## FIELD OBSERVATION REPORT

East Hardin Middle School, Hardin County Schools, Elizabethtown, KY 201752.01 - CA8

Date: 3/4/2021

Report No: 45

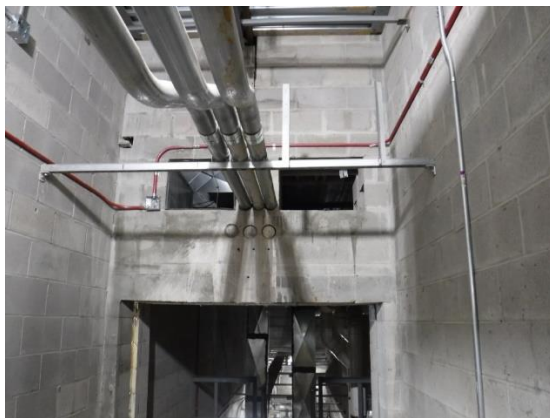
Doyle reported that Extreme Polishing will prepare sample slabs on March 11 and 12, 2021.

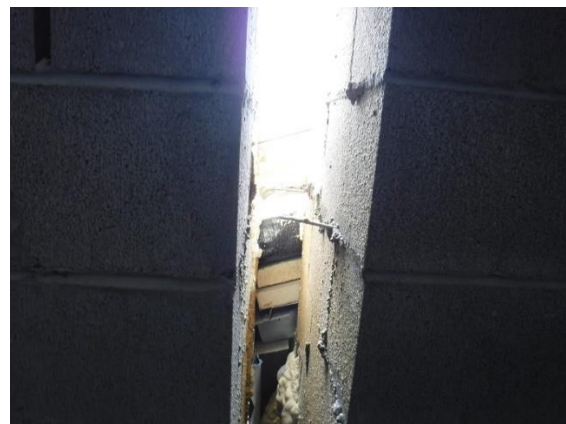
- d) Doyle confirmed that the electrical conduits passing through the two-hour fire resistive rated fire walls would be sealed with fire resistive sealant. The sealant must be installed based on a U/L fire resistant rated assembly for the spacing and size of the conduits.

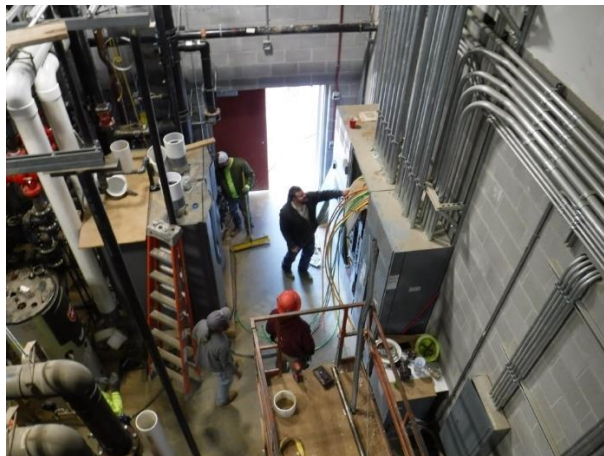
- g) Ductwork, hydronic lines and controls have been run to the heat-pump units over the main corridor.

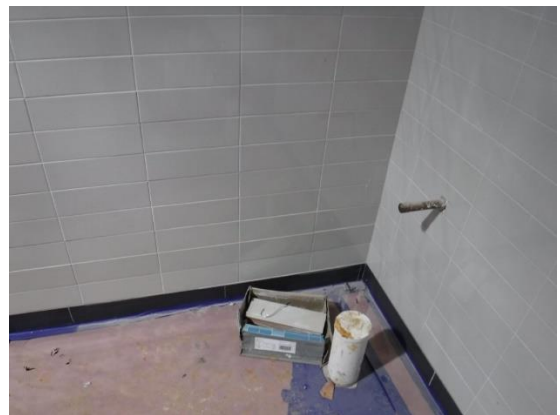
- p) Though it is difficult to see in the image, conduits and pipes have ended up exposed on the walls around the cafeteria. Doyle recommended that drywall soffits be added to cover these.

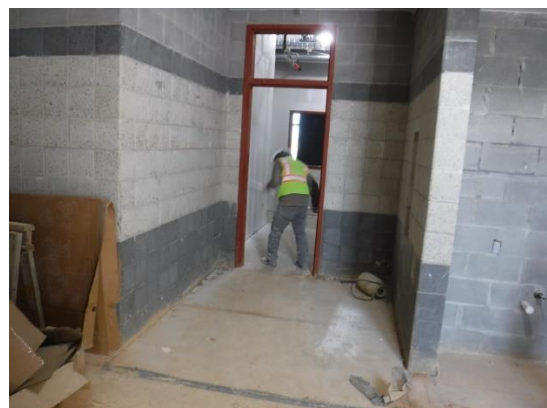
- u) The drywall soffits over the main corridor have received the first coat of paint.
